Awel y Môr Offshore Wind Farm

Application Errata List (Clean)

Document Reference: 8.39

FIGURE NUMBER:
Figure 1

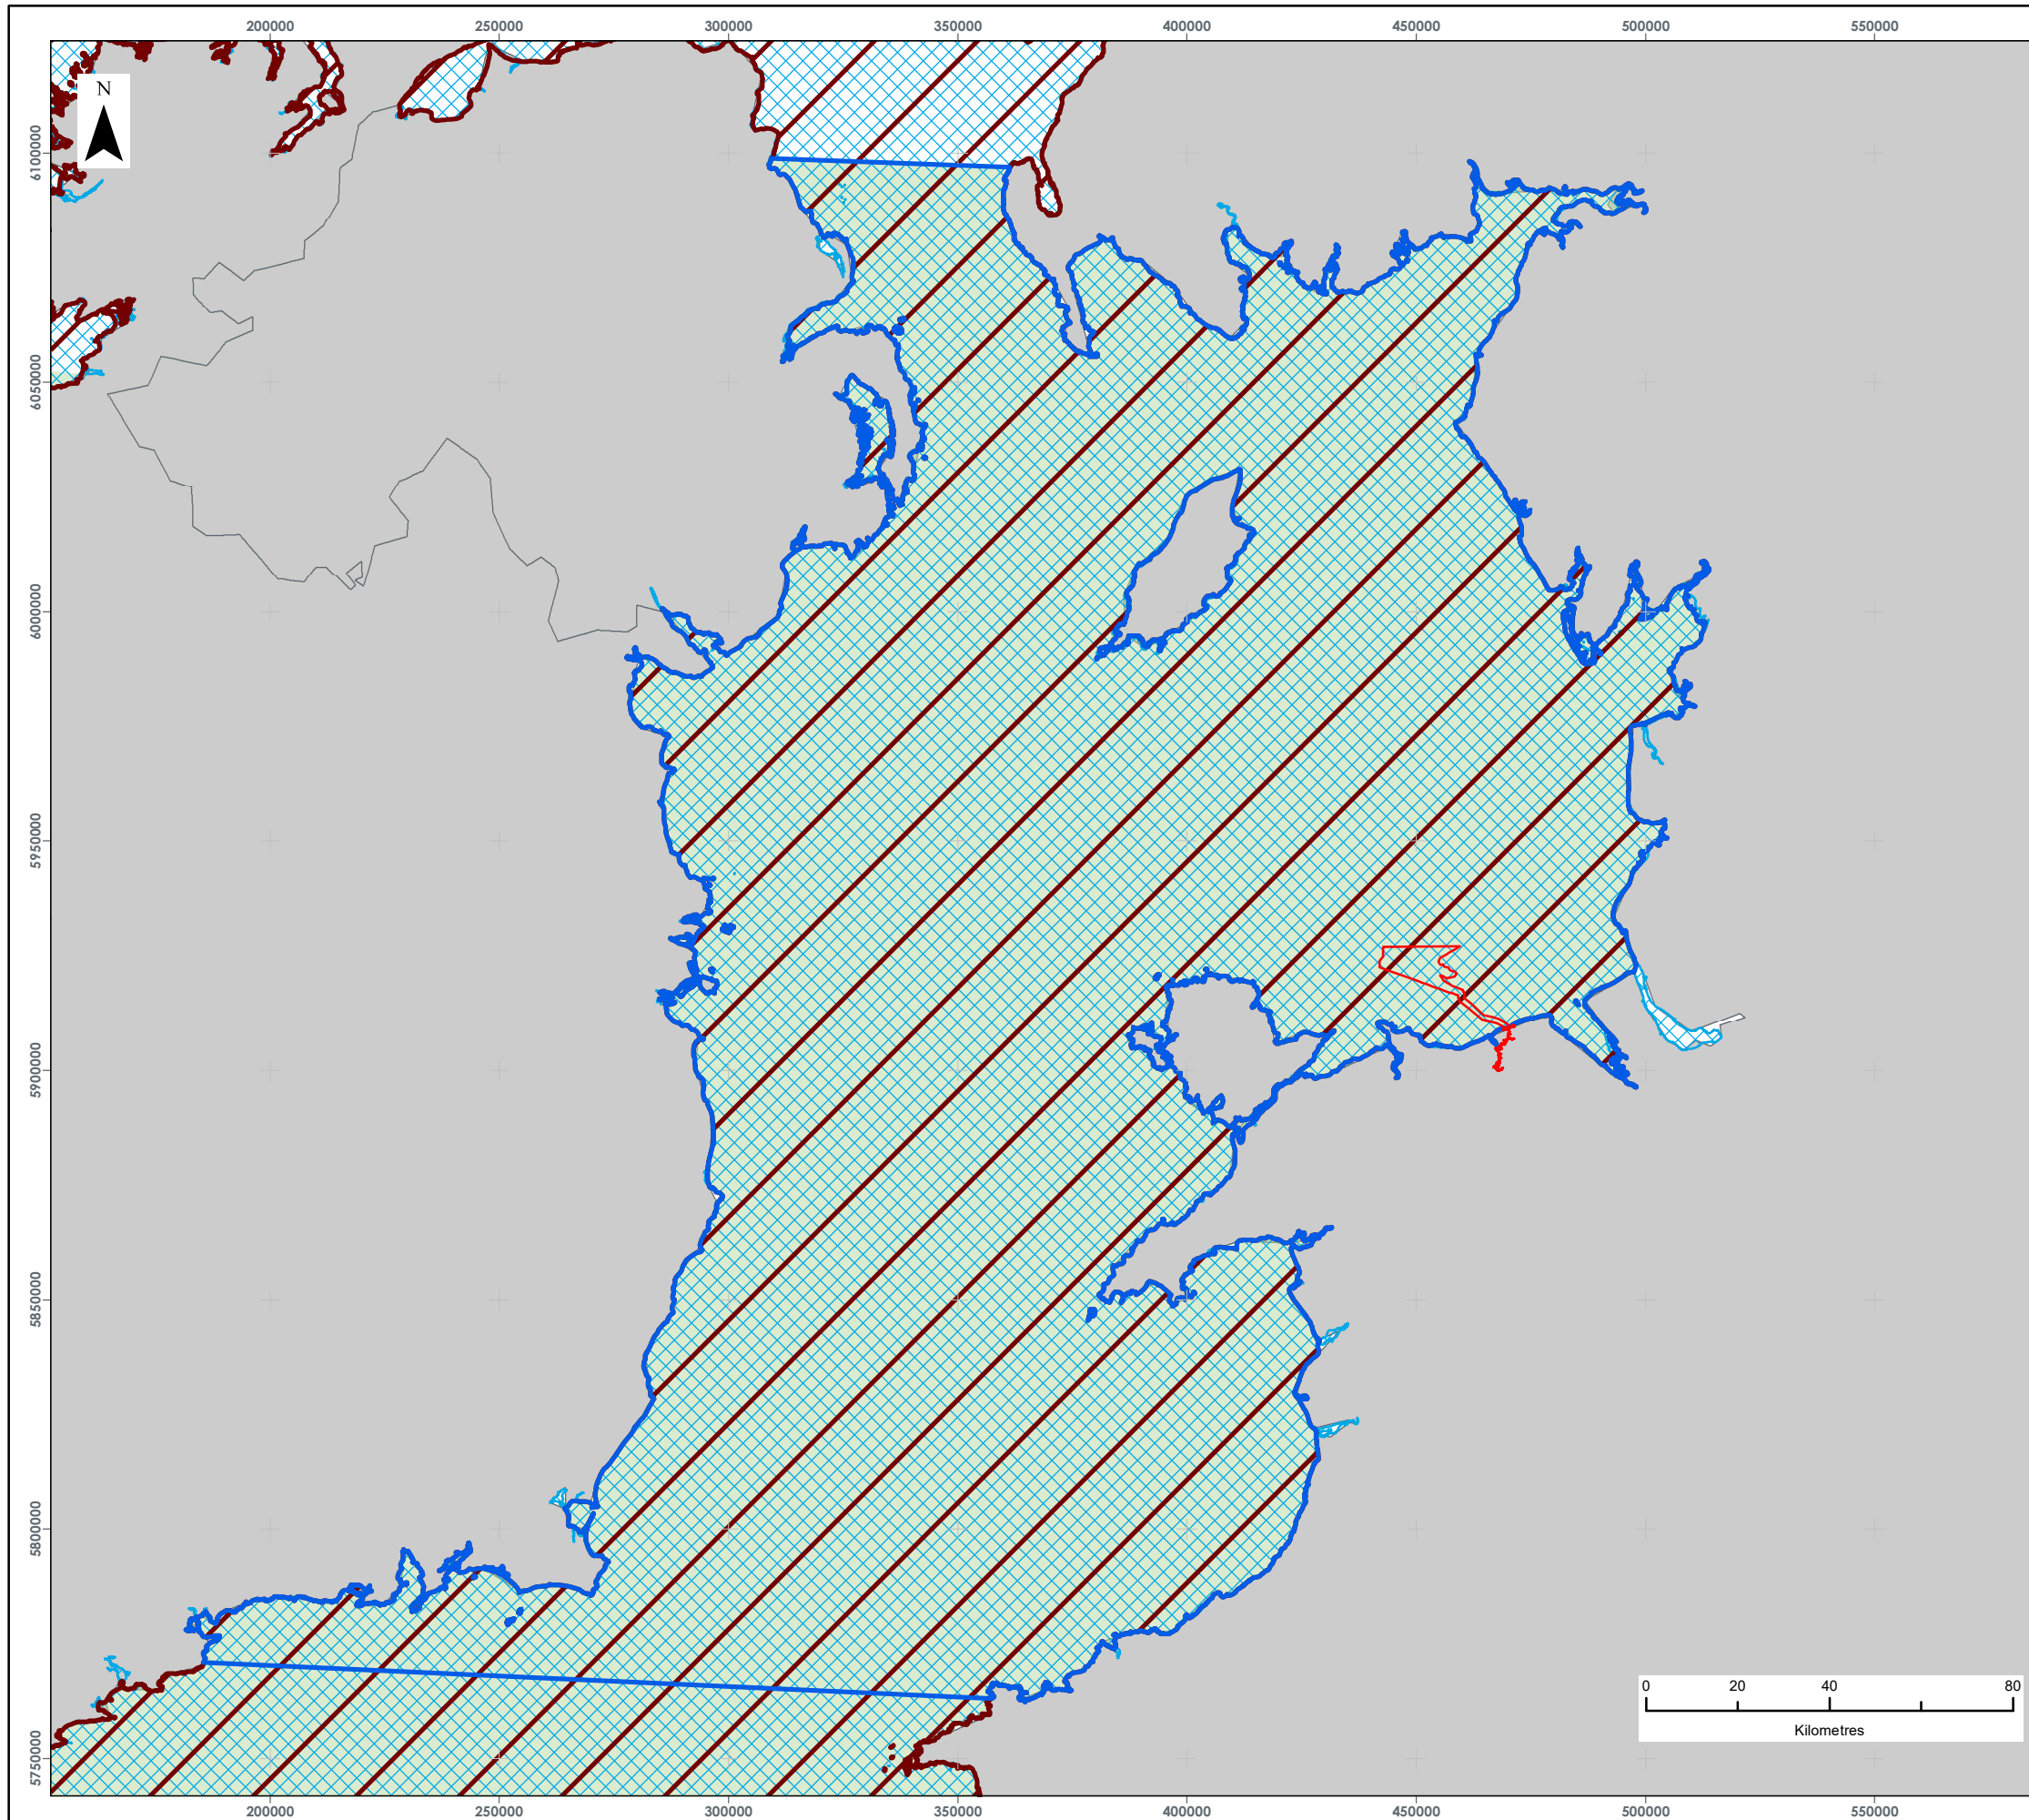
- 8 For completeness, the correct figures are appended to this document in Appendix A, duplicated from the figures presented in APP-053:
 - ✦ Figure 1: Figure incorrectly displayed a black background and omitted base mapping. Corrected figure provided in Appendix A of this document. Note this figure is identical to Figure 1 presented in APP-053.

FIGURE NUMBER:
Figure 2

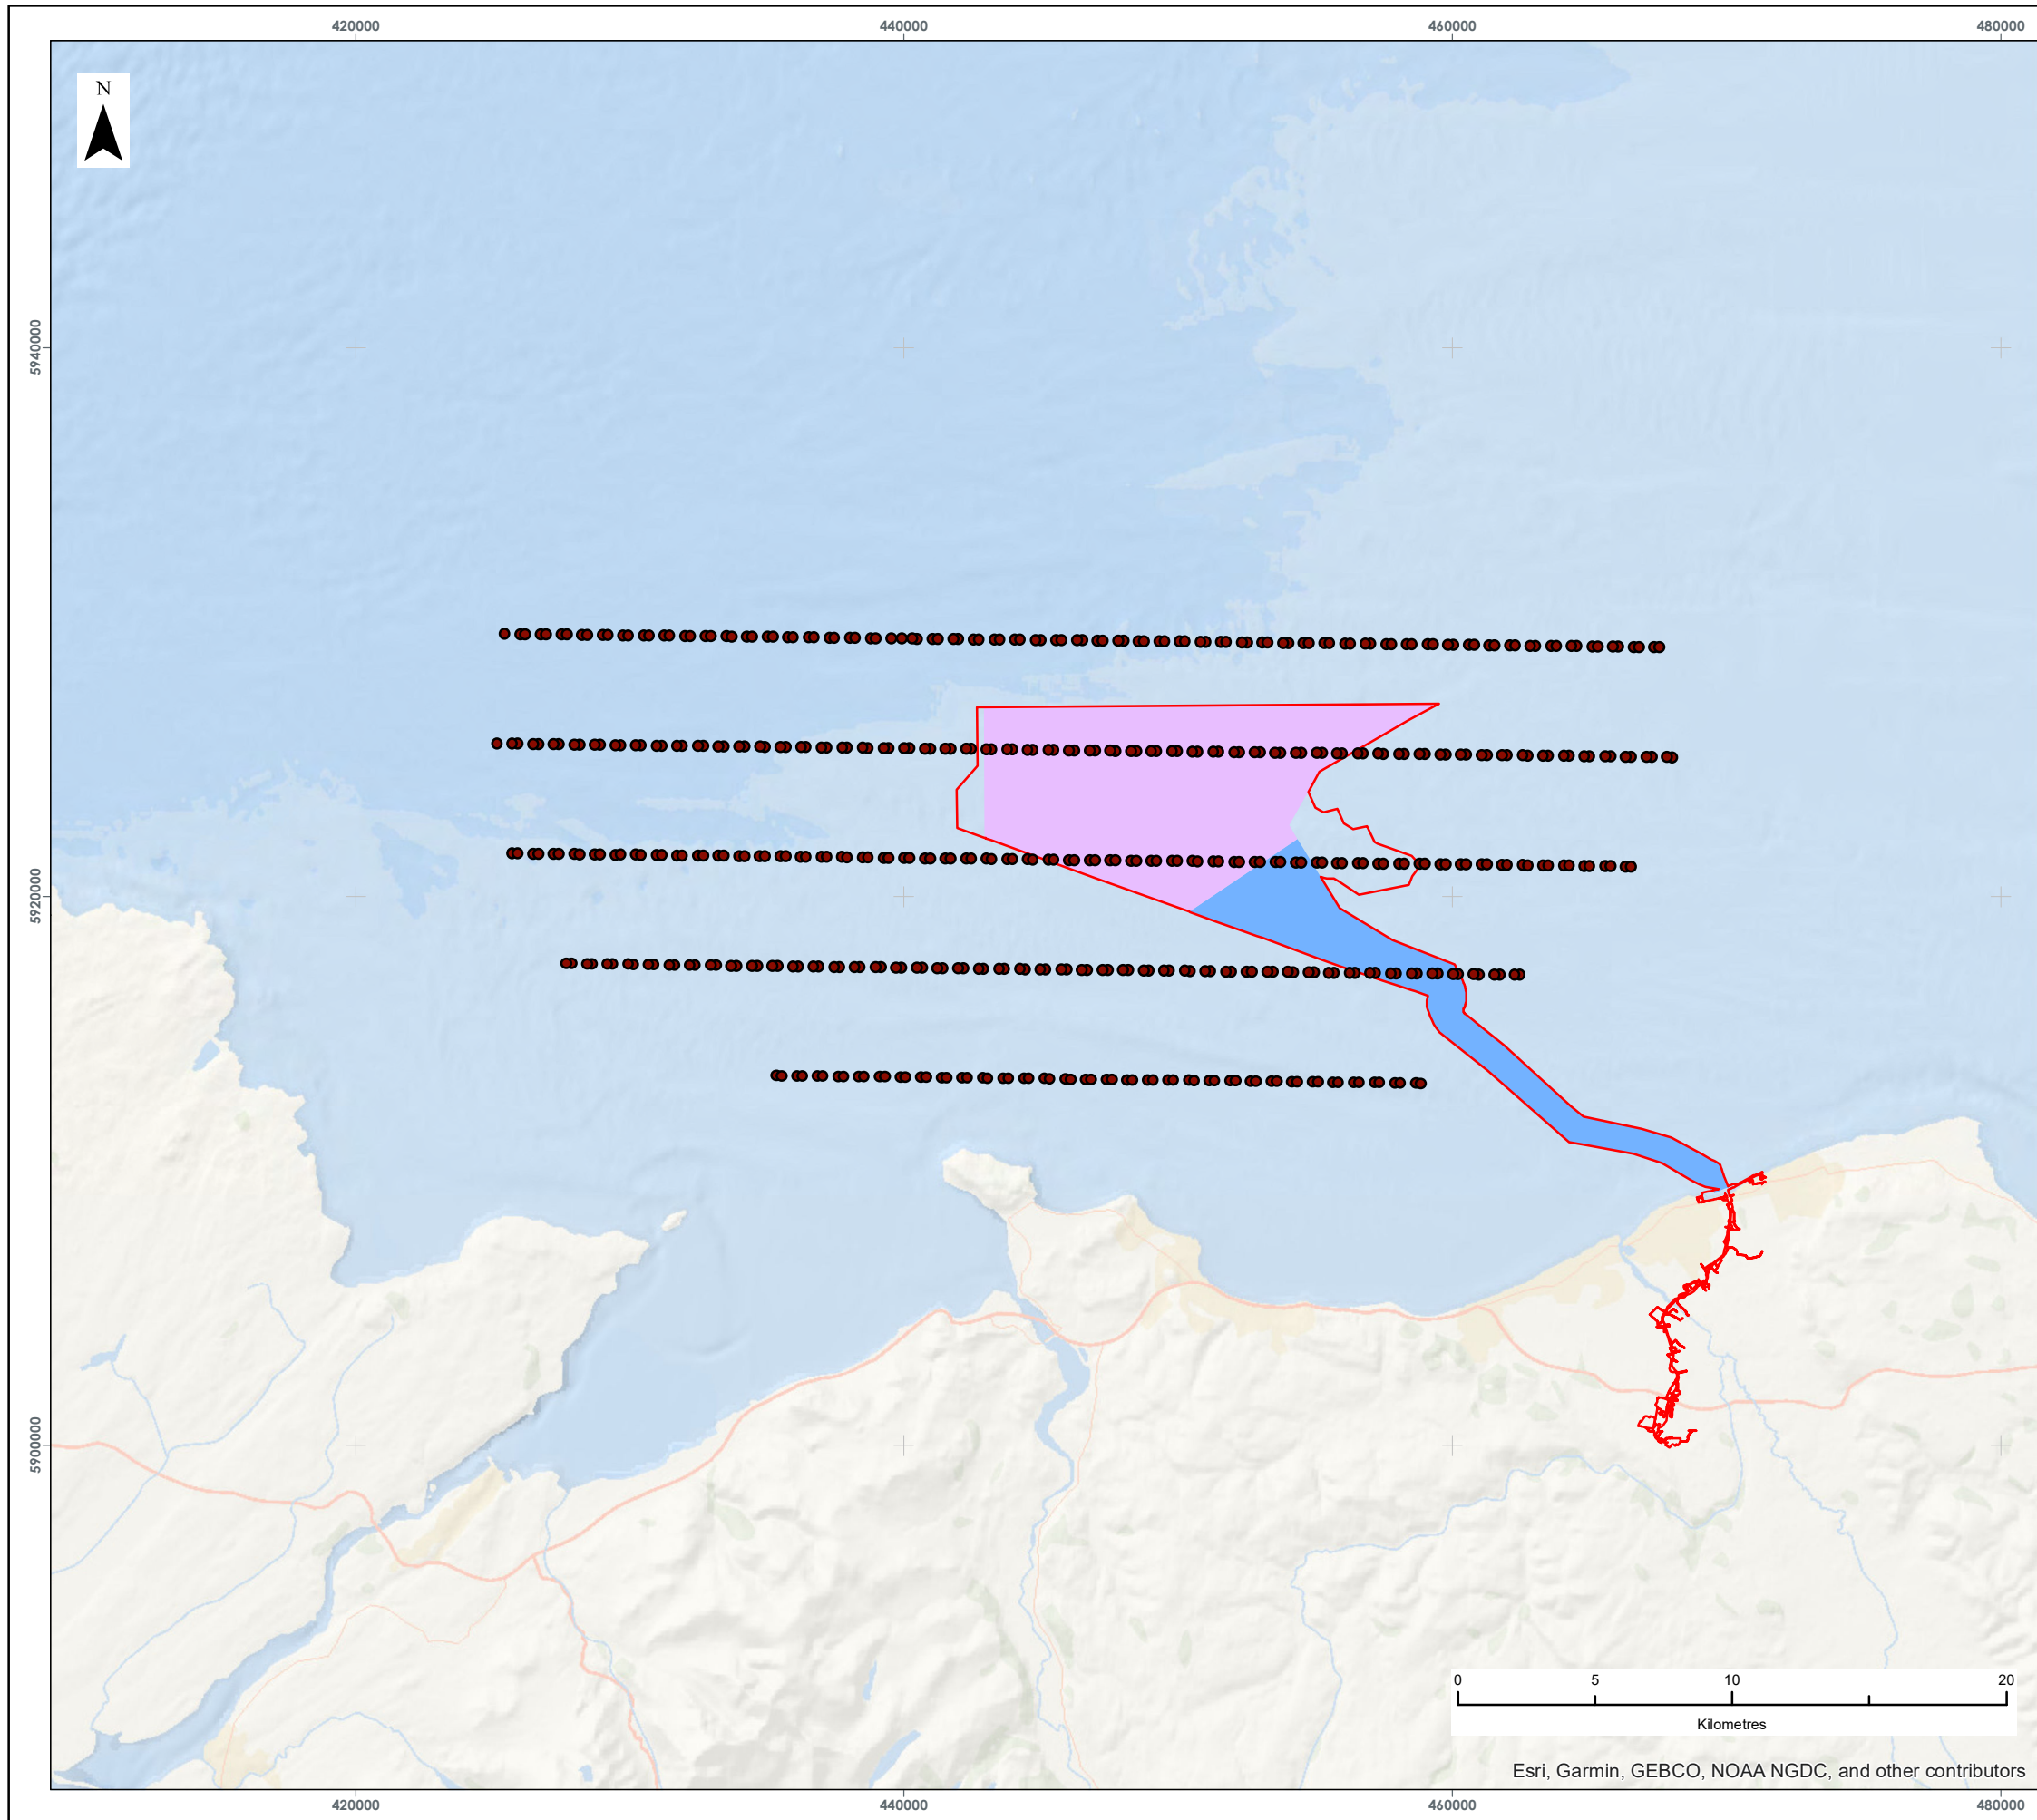
- ▲ Figure 2: Figure incorrectly displayed a black background and omitted base mapping. Corrected figure provided in Appendix A of this document. Note this figure is identical to Figure 2 presented in APP-053.

FIGURE NUMBER:
Figure 18

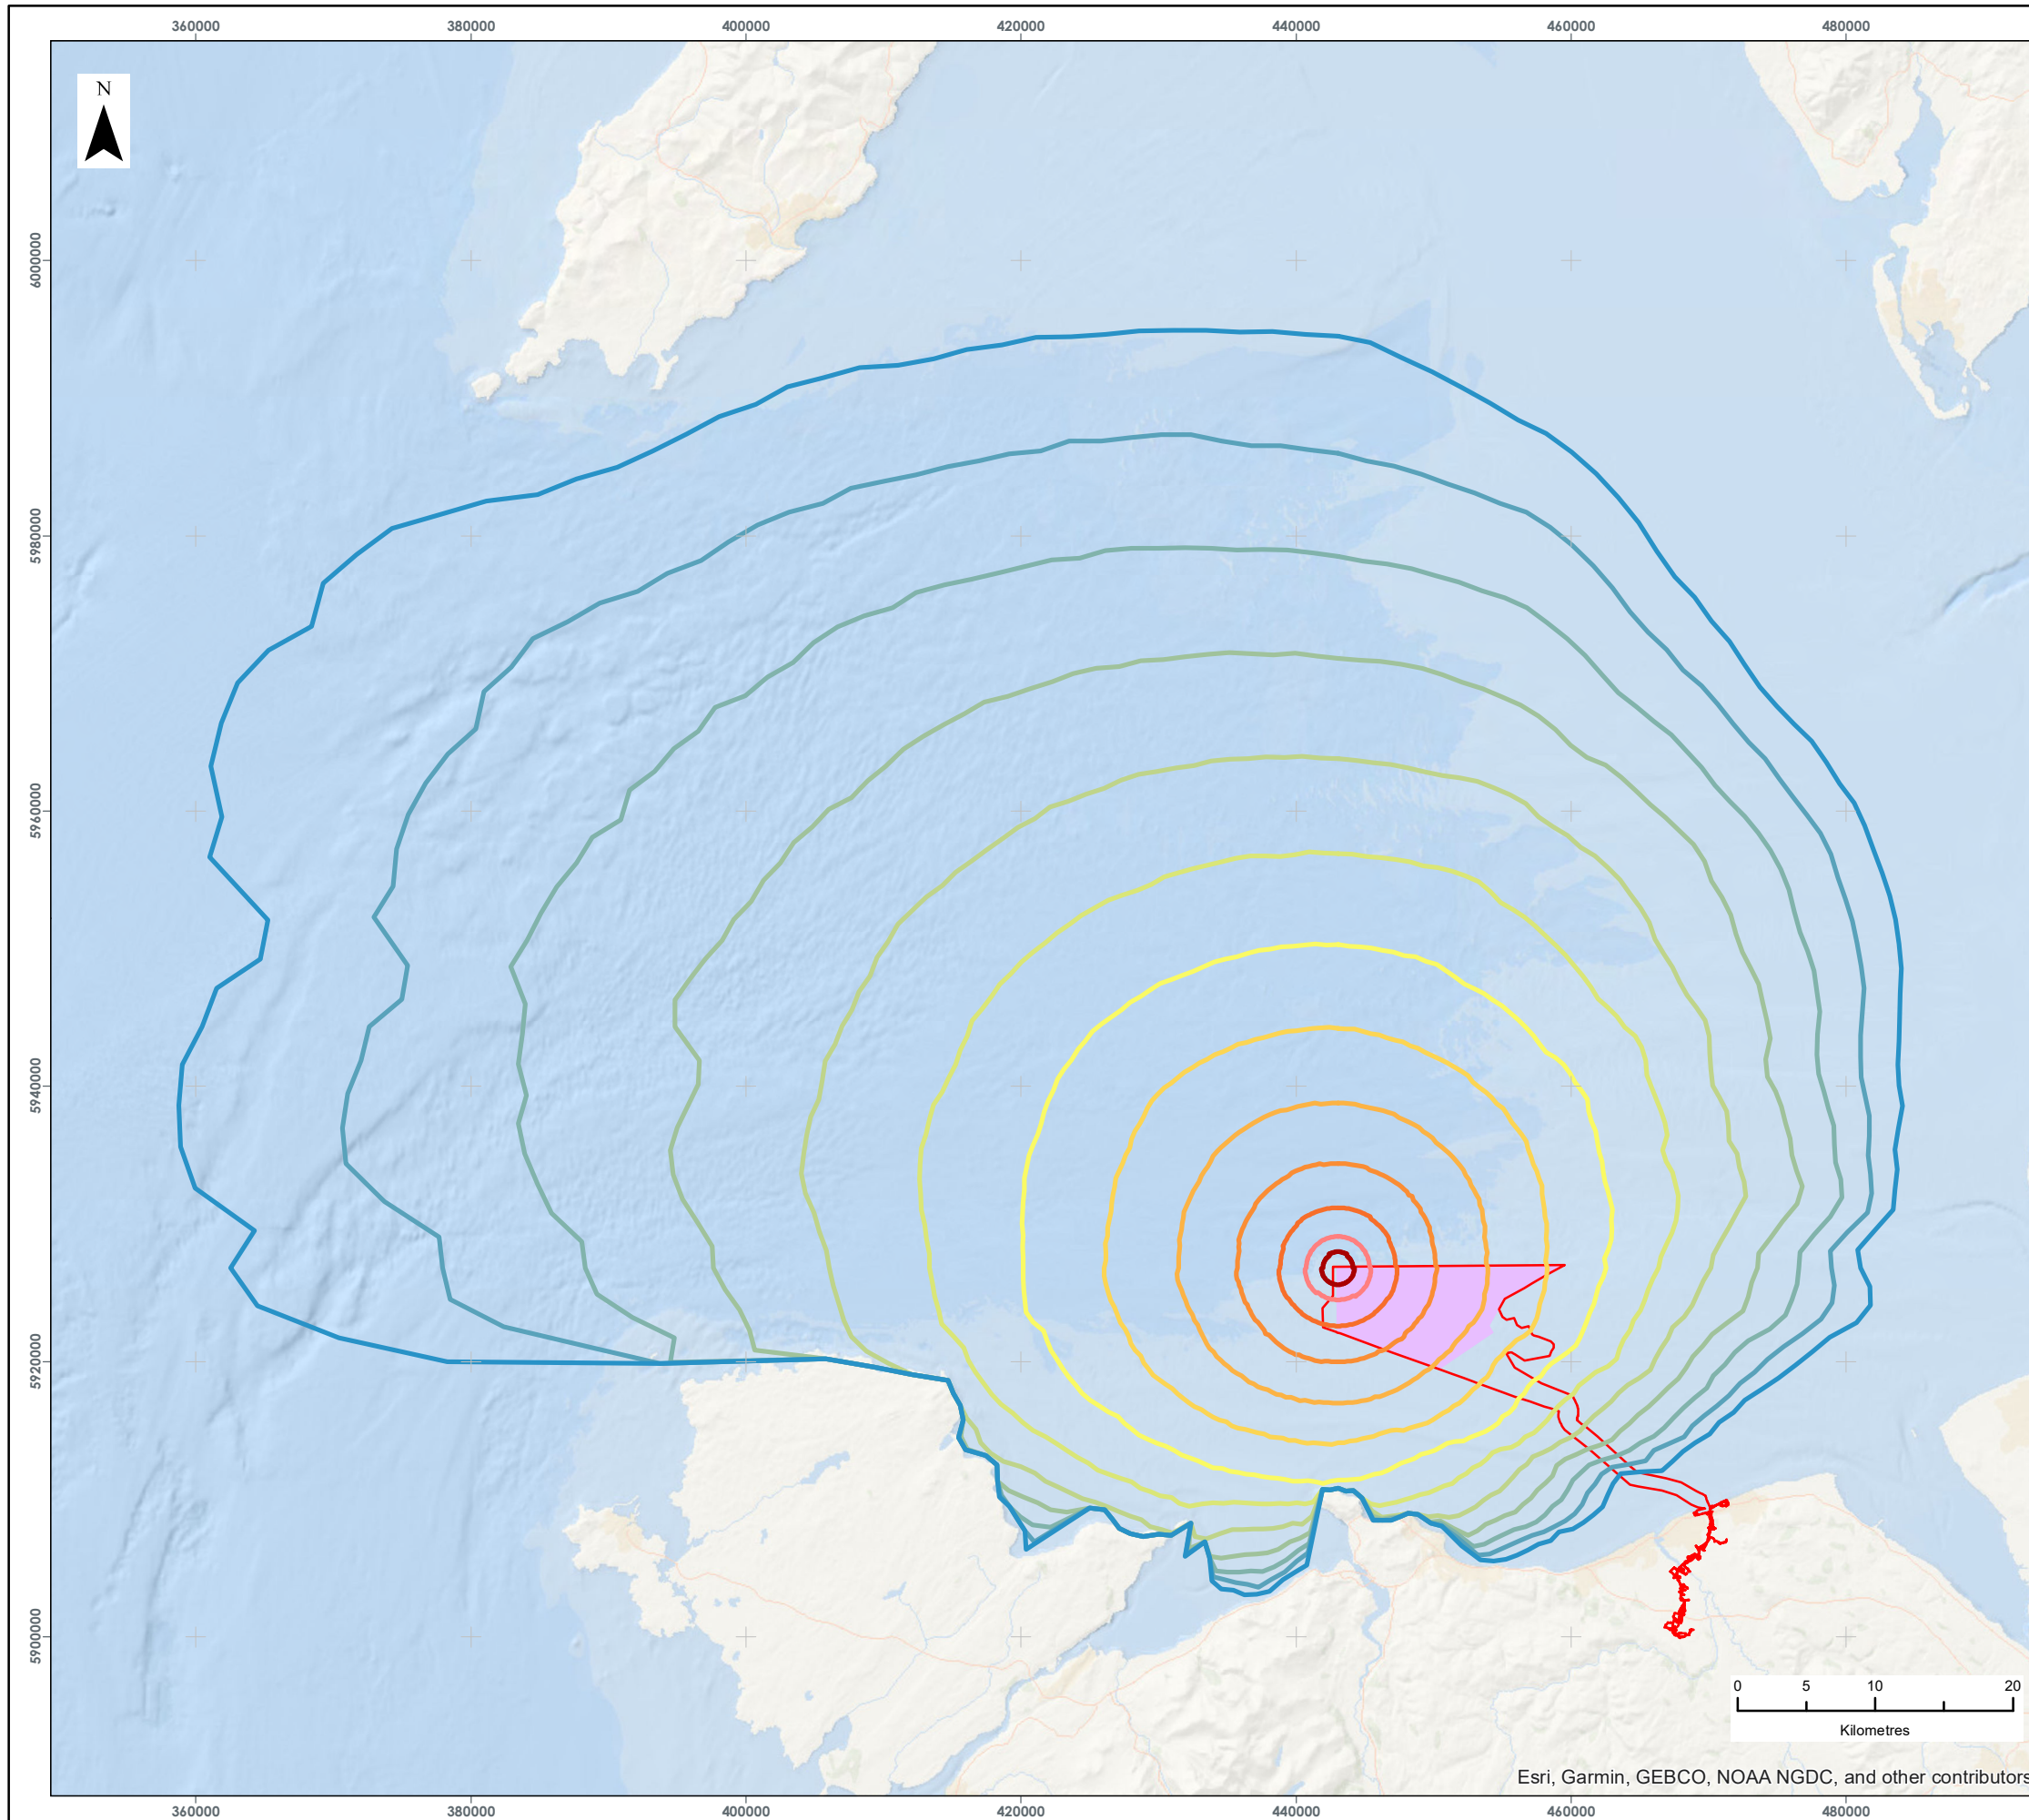
- ▲ Figure 18: Figure incorrectly displayed a partial black background and omitted base mapping. Corrected figure provided in Appendix A of this document. Note this figure is identical to Figure 18 presented in APP-053.
